Safety recommendation: AIC 19-R12/18-1004

Addressed to: Air Niugini Limited

Date issued: 25 February 2019

Reissued Recommendation number AIC 19-R12/18-1004 to Air Niugini Limited

7.11.19.3 56 - Man Liferaft / 46 - Man Liferaft / 36 - Man Liferaft

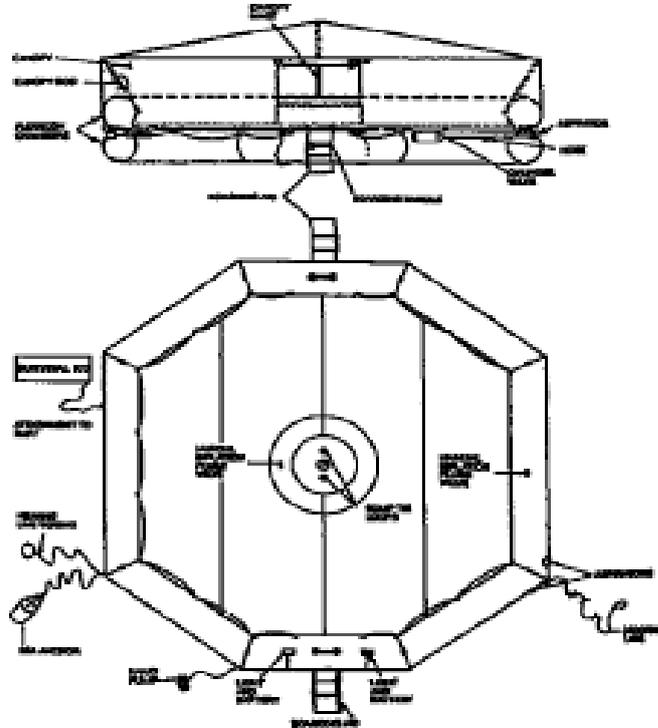
Section 7.11.19.3 of the *Air Niugini Training Reference Manual* has diagrams of an inflated life raft (a side view and a plan view), but the captions describing the various parts of the life raft are very small font and blurred and therefore are unreadable, and provide no assistance to the user. (*See Appendix*)

Air Niugini also provided documentary evidence of the safety action taken with the CASA PNG accepted² amendment of the *Safety and Emergency Procedures Manual (SEPM) Vol 6, Section 2.14.4.1* to require the life raft to be launched outside the aircraft. This amendment reinforces *Section 7.11.19.3* of the *Air Niugini Training Reference Manual*. The diagram and descriptors on drawings of the life raft have been redrawn to make them clear and unmistakable. (See page 5)
